# Technical News

Ref. No.	Issuer company	Issue (yyyy/mm/dd)	Last modification (yyyy/mm/dd)
PV20NEX534	Digital Imaging Group	2021/04/28	
<b>Subject</b>			
Repair services to replace LCD panels			
Model (System model)	Destination	Serial number	Color
ILCE-6400	All	ALL	All

JDI Current product	Innolux Modified product
Part name	LPM030M340C	ED030SC-05A
Part number	1-812-461-11/-21	1-009-402-11
FPC		
FPC

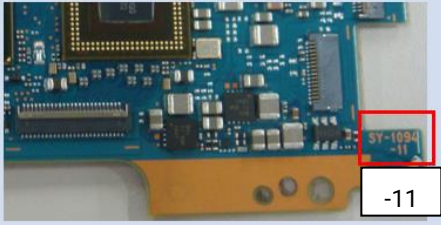
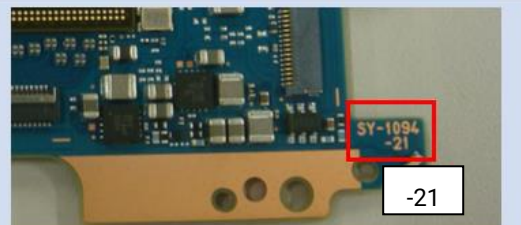
SY bord and software both need to change, because LCD panel maker changed.

Refer the table how to distinguish LCD module.

How to distinguish old SY board and new one. (ILCE-6400)

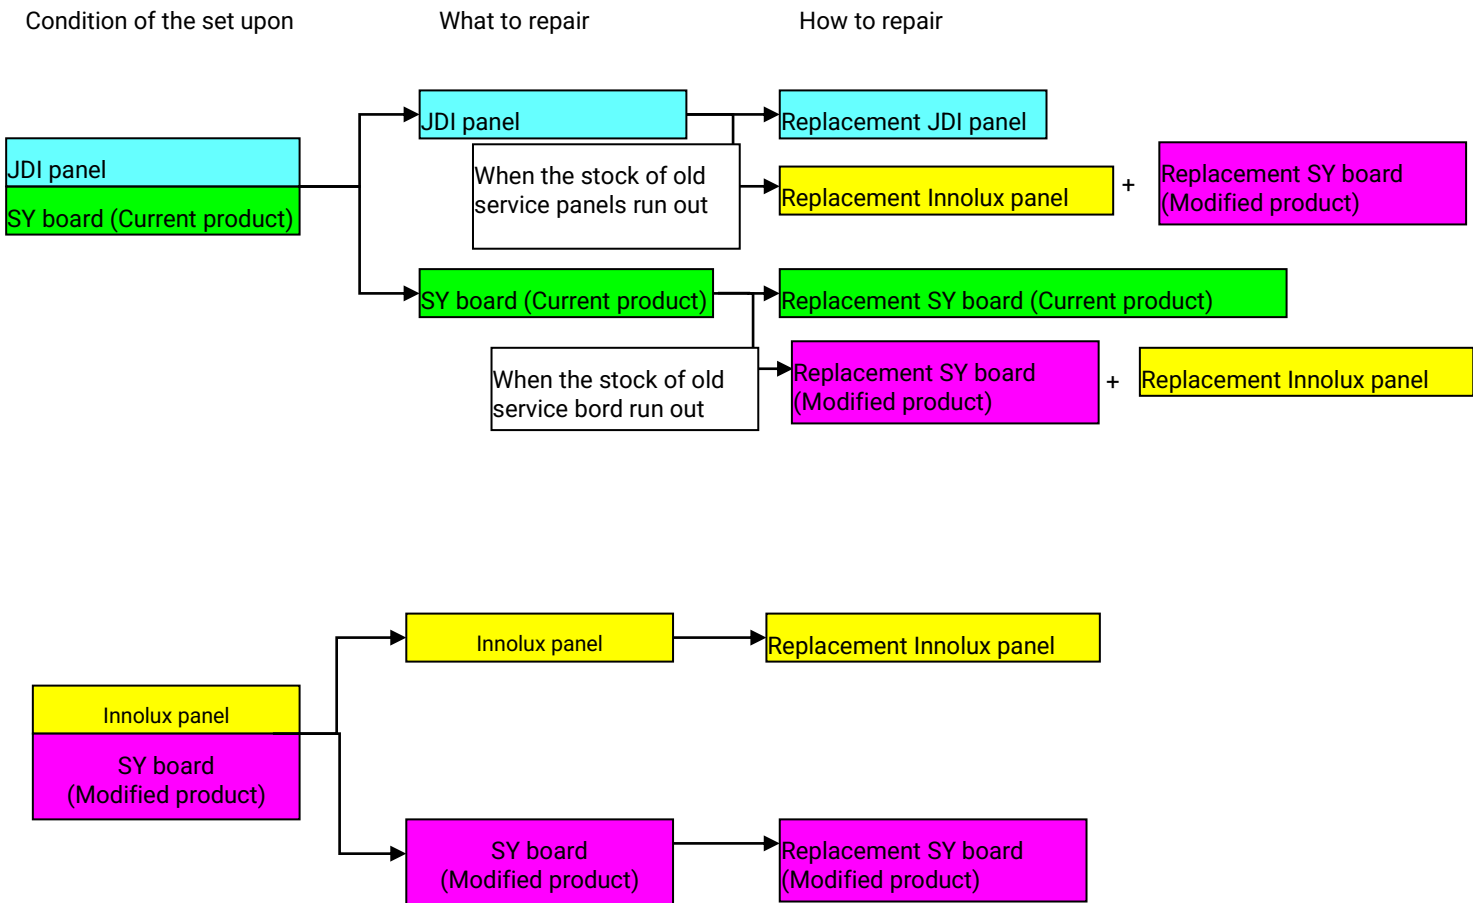
Current product	Modified product
Part name	SY-1094	SY-1094
Part number	A-5009-198-A	A-5031-600-A
SY Board

-The service main board is equipped with a corresponding panel FW at end. When writing to the destination, select according to the corresponding panel.  
 -When using a new board, please use a version newer than "ILCE-6400\_Series\_AM\_Ver\_1.4\_x64" for the adjustment software.
